INFORMAL MEMO

Re: Nov. 10, 2010 DRC PA Workshop

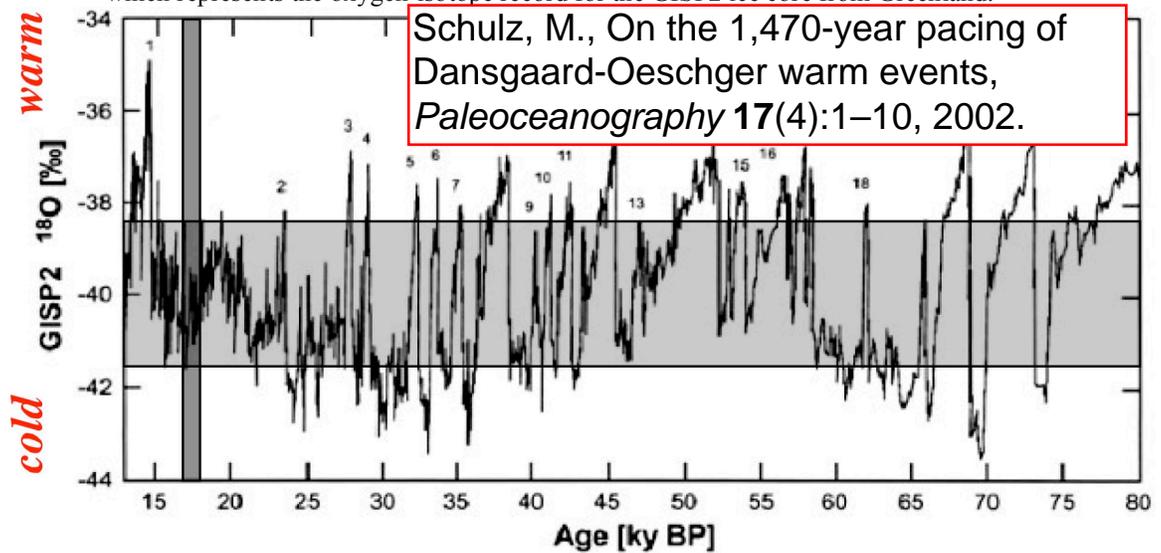
- Flooding is also likely to occur repeatedly during subordinate high-frequency fluctuations recorded in ice core during the run up to full glacial conditions. It will be very easy to underestimate the rate of return of shorelines to Clive. This is illustrated in the figure, which represents the oxygen-isotope record for the GISP2 ice core from Greenland.

An ice core in Greenland is, admittedly, a poor proxy for Lake Bonneville elevations. But it nonetheless illustrates the frequency and magnitude of potential climate variations in the northern hemisphere, and thereby the frequency of climate events that might drive lake level rise. The vertical shaded bar represents the time span of the Bonneville stage of the lake, when it was deepest. It *ignores* the Stansbury and Provo stages when the Clive site was also deeply inundated. The horizontal shaded bar represents the range of climate conditions prevalent during the Bonneville stage.

Note that high-frequency climate variations, with return intervals on the order of just a few thousand to a few hundred years, cross the horizontal bar on both the warm and cold sides *dozens of times* over the last 80 ka. No wonder we see so many shorelines in the Bonneville basin at elevations above and below Clive.
